PLANNING COMMISSION MEMO

ITEM DESCRIPTION: Zoning Case 19-03: Final Plat and Site Plan – Blackhoof Development, 14th Street Apartments

MEMO

SUBJECT: 14th Street Apartments - Building 3 – 3rd Review

DRAWING TITLE:
LANDSCAPE AND EROSION CONTROL

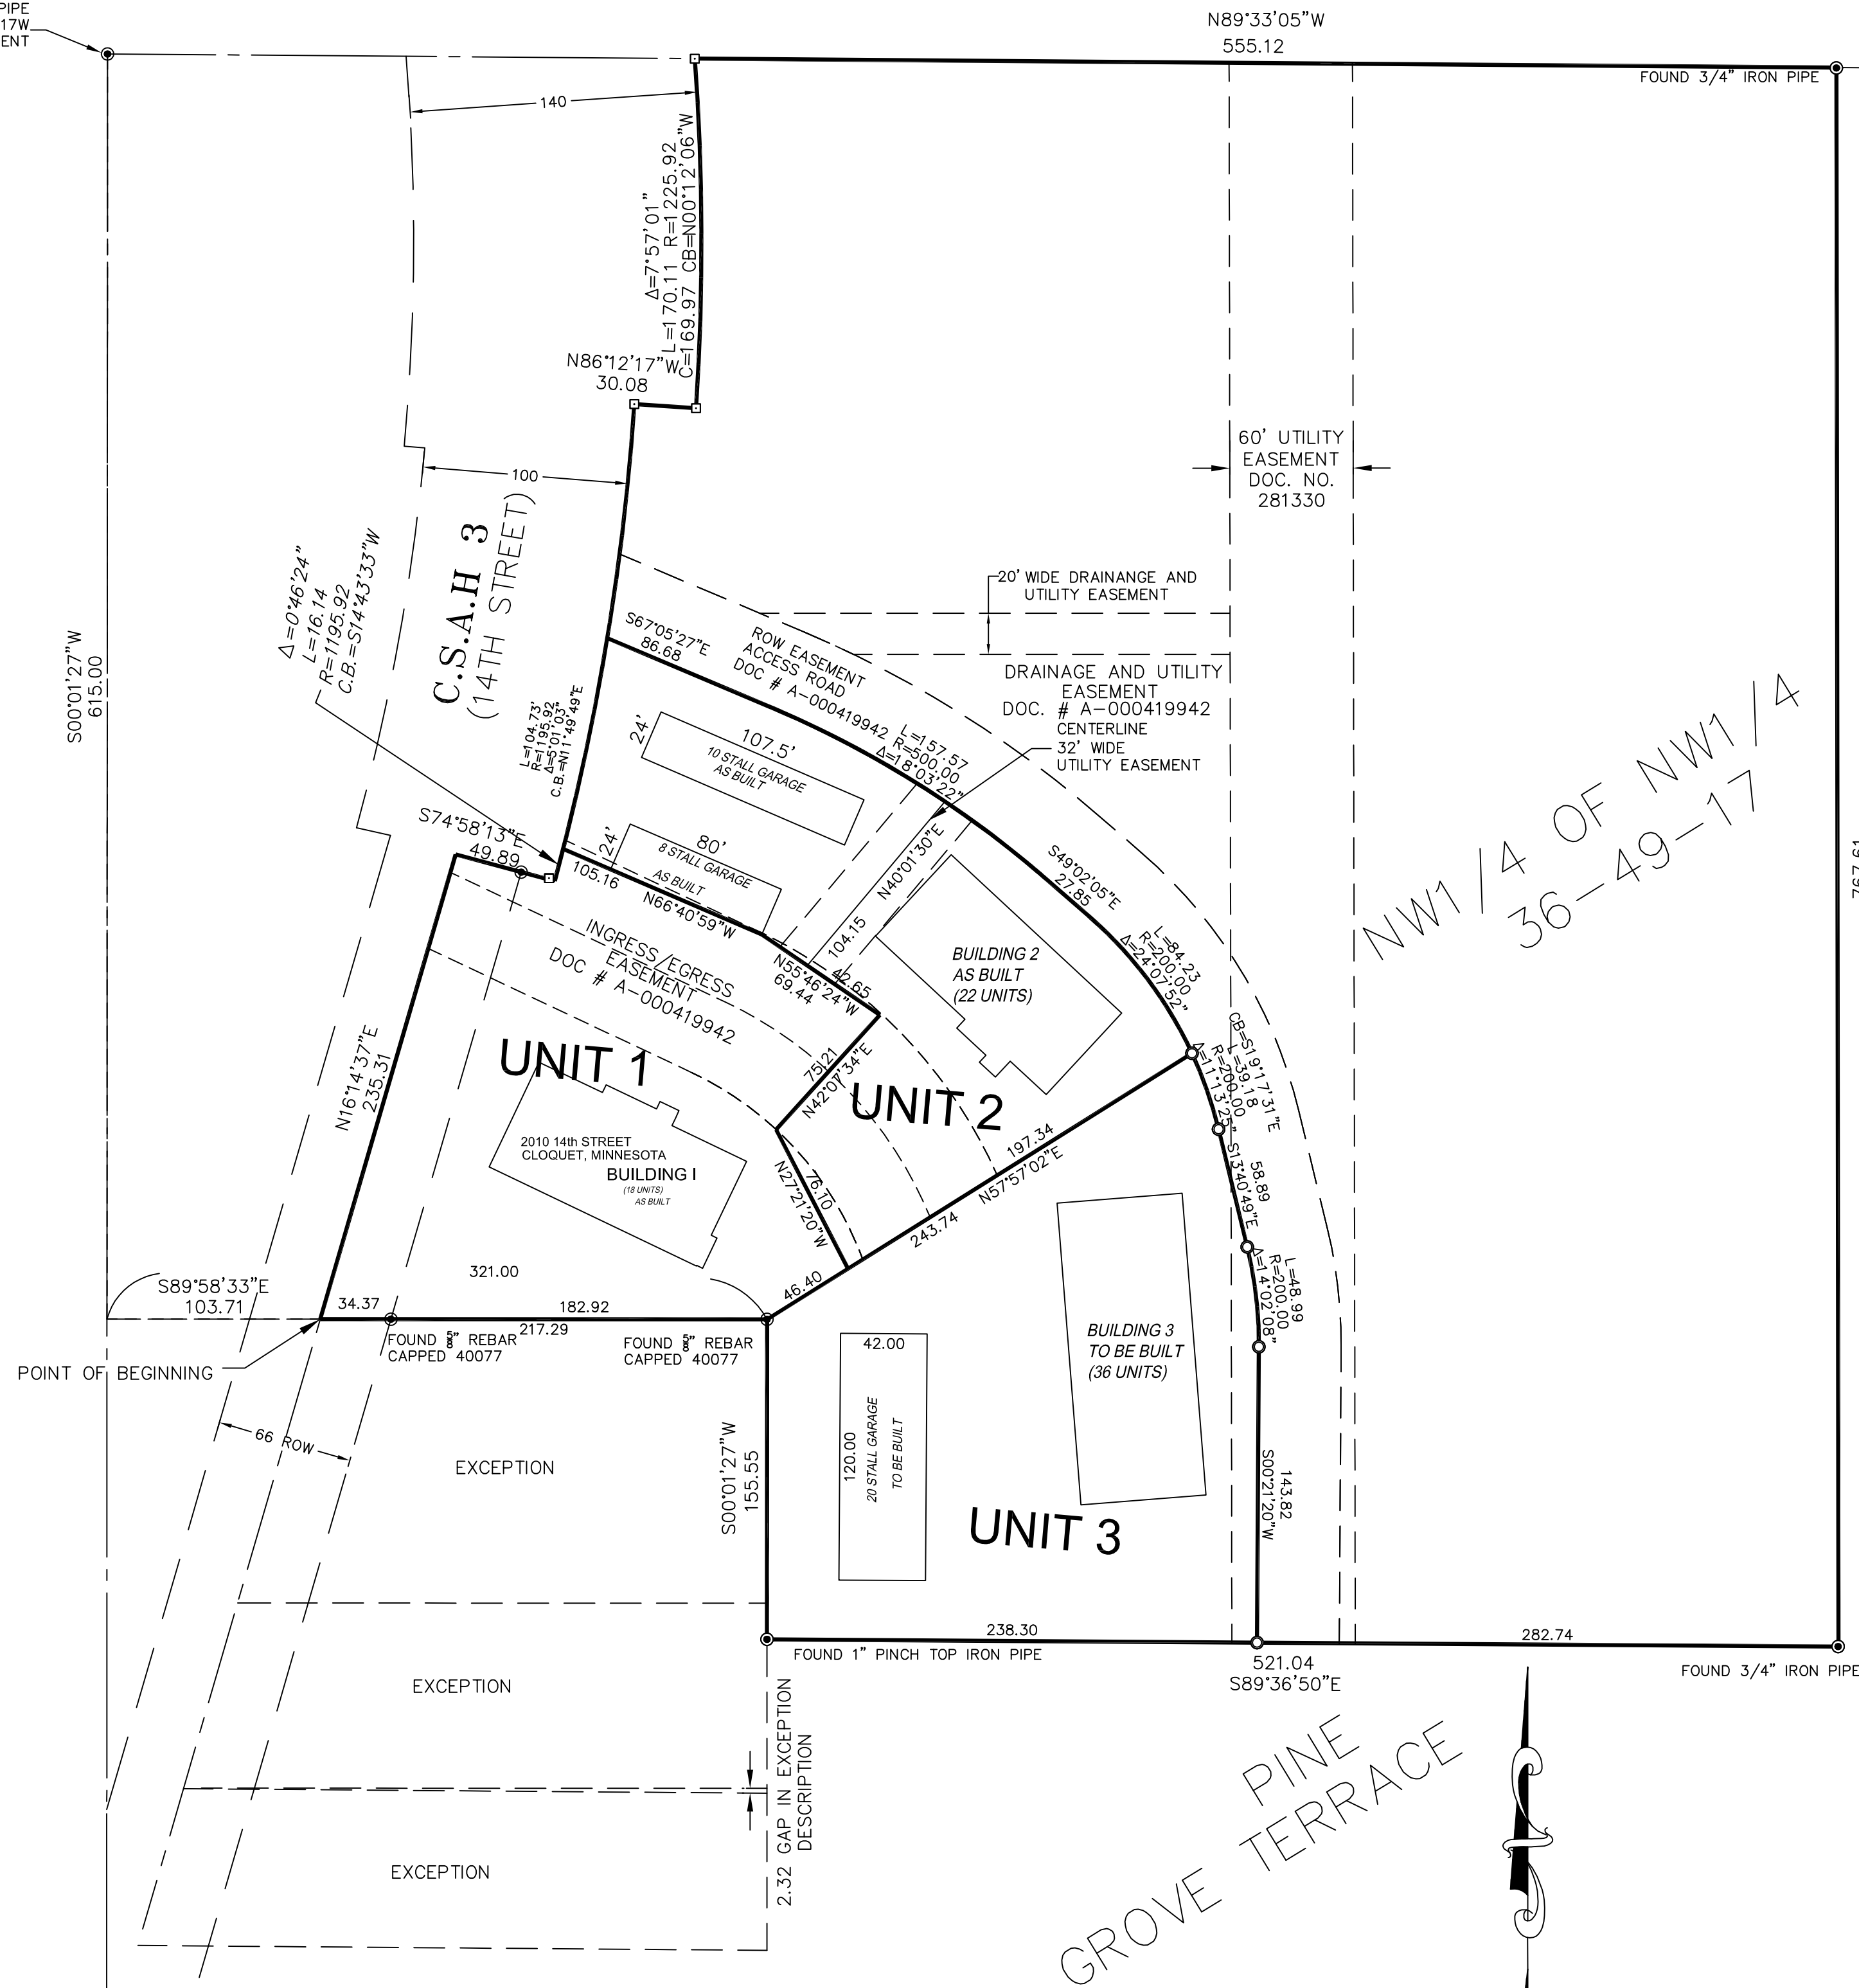
1. Adequate protection of the existing onsite infiltration (pond 5P) must be included in the erosion control plan to protect the sites ability to infiltrate stormwater. The plans do not show how the existing infiltration areas will be protected from silt during construction.
2. The contractor will be required to inspect the site as required by the NPDES permit, copies of these inspections shall be provided to the City of Cloquet. These inspections must be preformed by qualified inspectors and installation of erosion control measures must be preformed by qualified installers. The contractor shall submit the credentials of all personnel responsible for inspection and installation.
3. Perimeter control needs to be included in the plan along the western boundary of the site.
4. Pond P-3 needs to be protected from compaction and siltation during construction.

DRAWING TITLE:
GRADING AND DRAINAGE

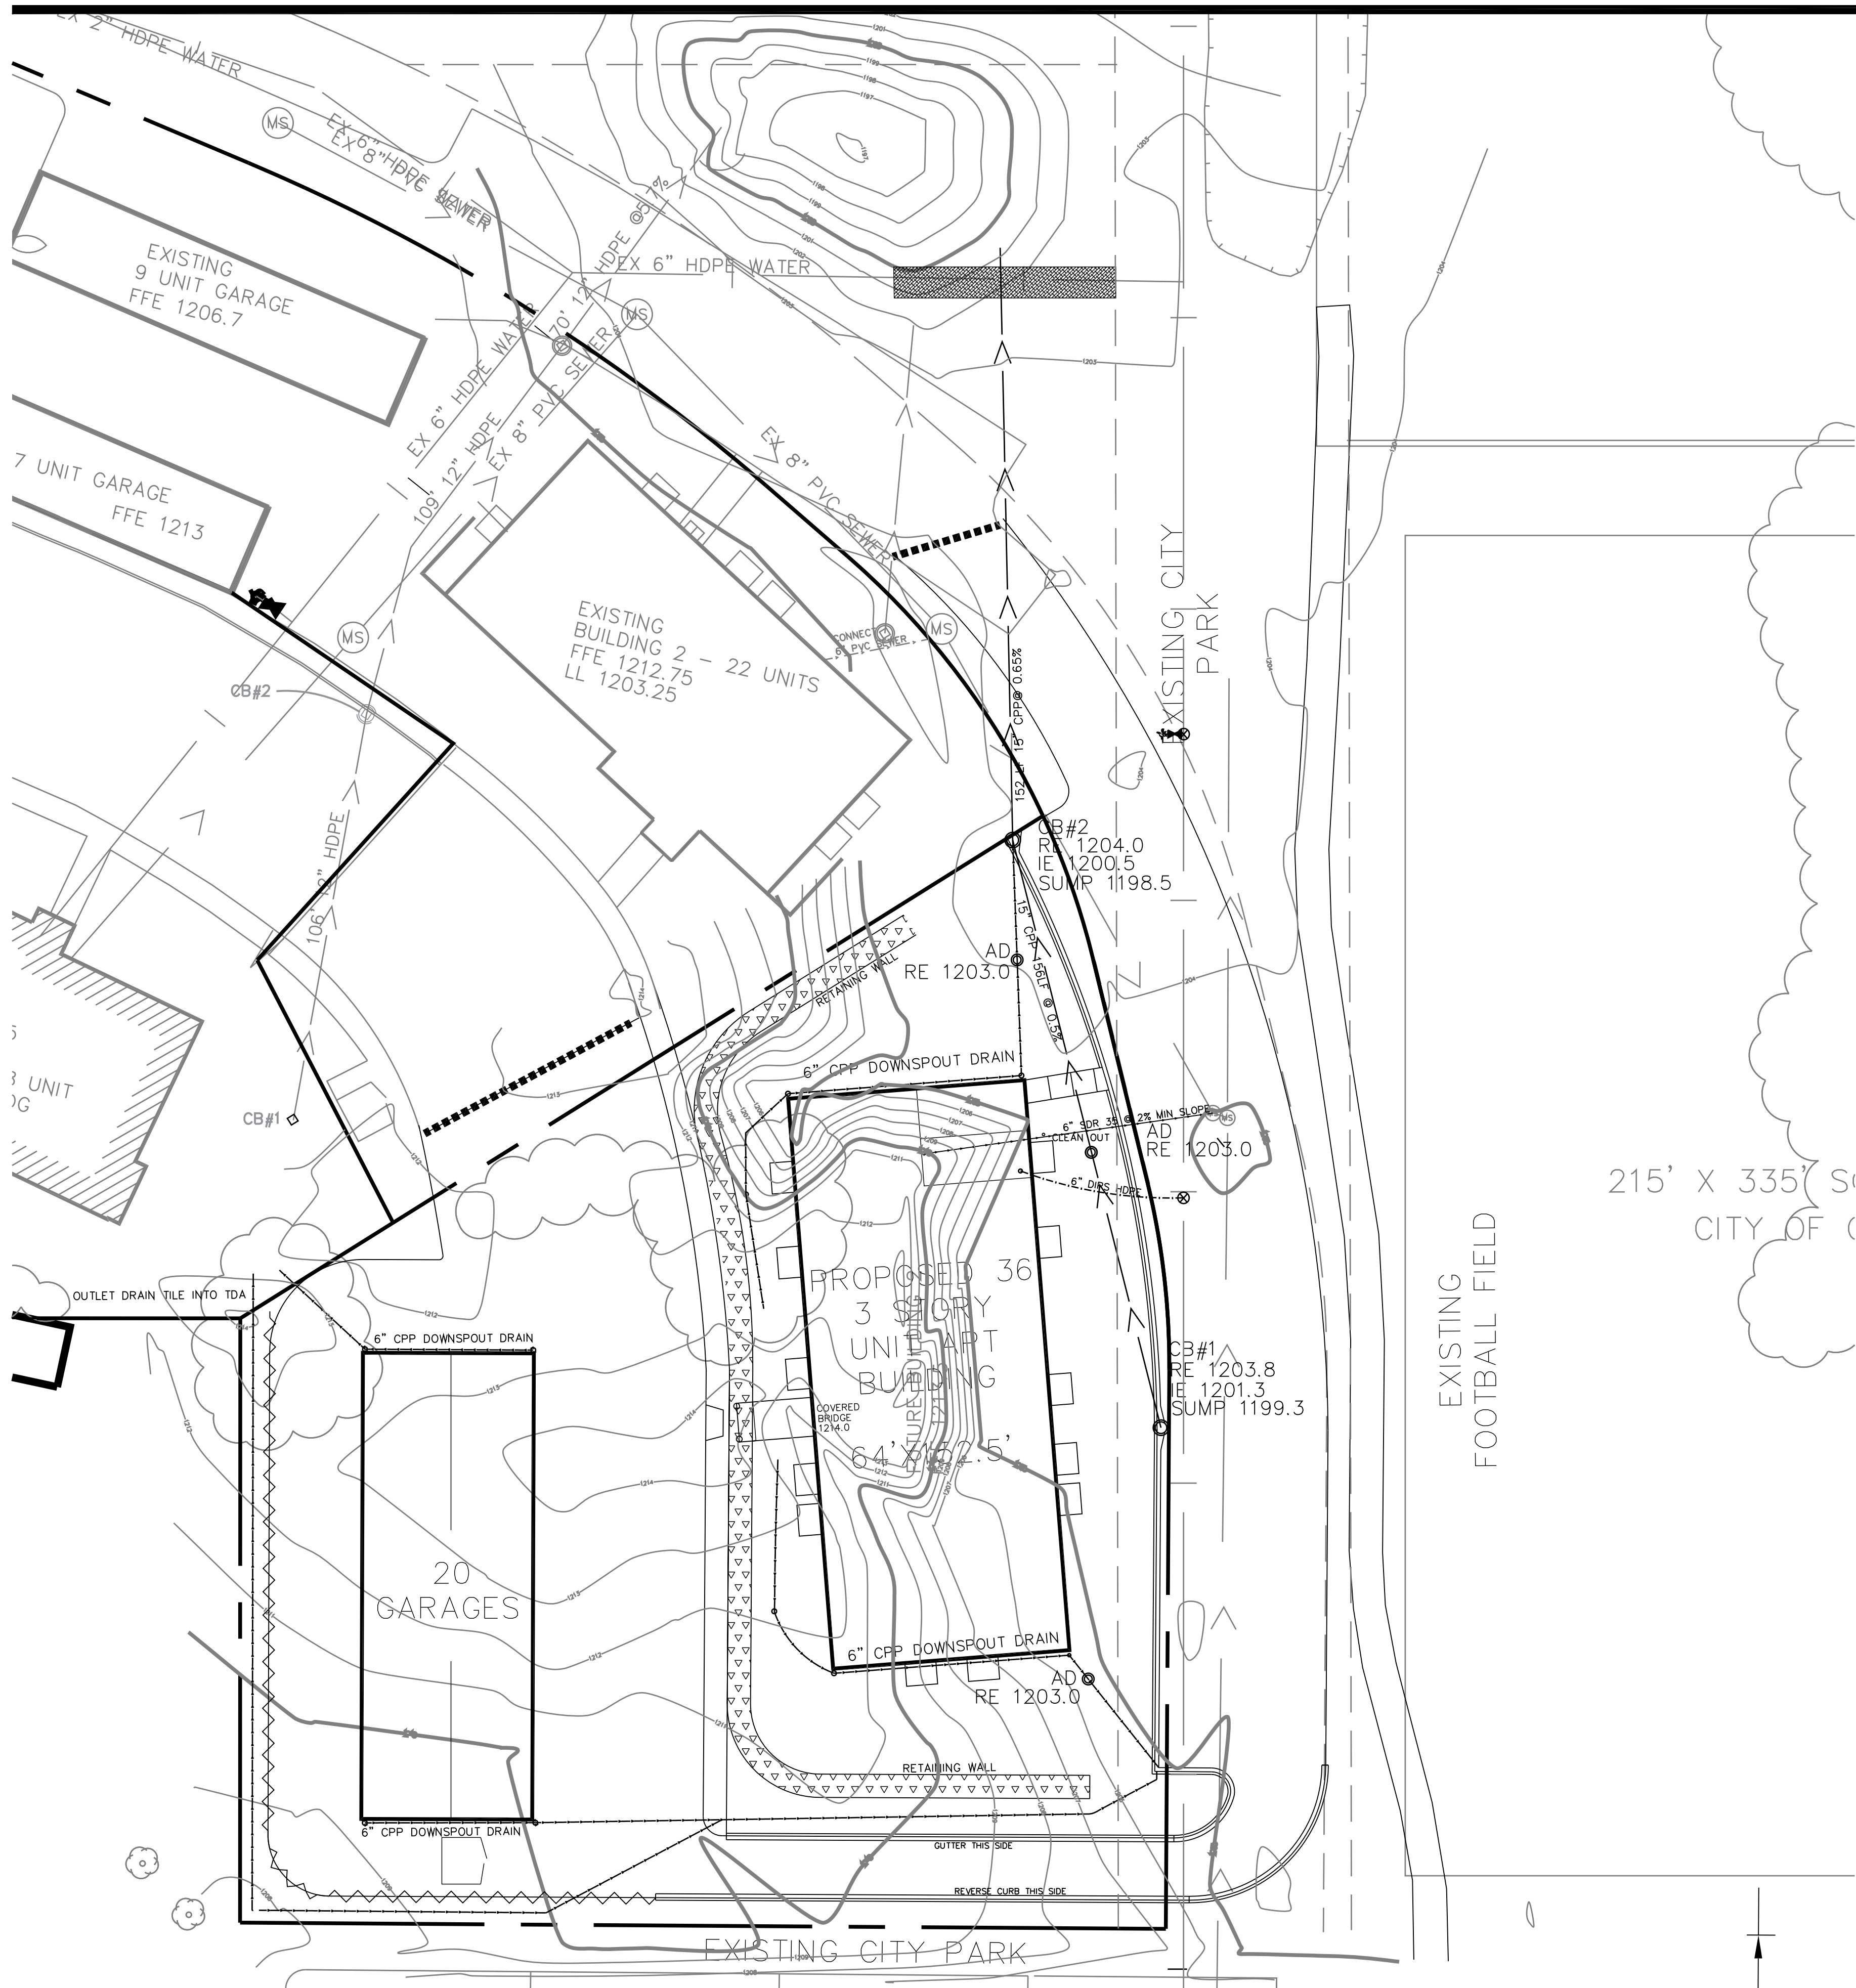
1. An engineered design shall be provided for the retaining wall.
2. An engineered design shall be provided for the bridge connection to the building.
3. This plan will require a NPDES construction permit as well as a city issued grading permit.
4. The site will be required to establish a stormwater utility account and contribute based on the amount of impervious on site
5. A bond in the amount of \$5000 will need to be provided to insure proper function of the stormwater treatment pond.
6. Pond P-3 is not clearly defined in the plans. Details of areas, elevations and construction materials need to be provided
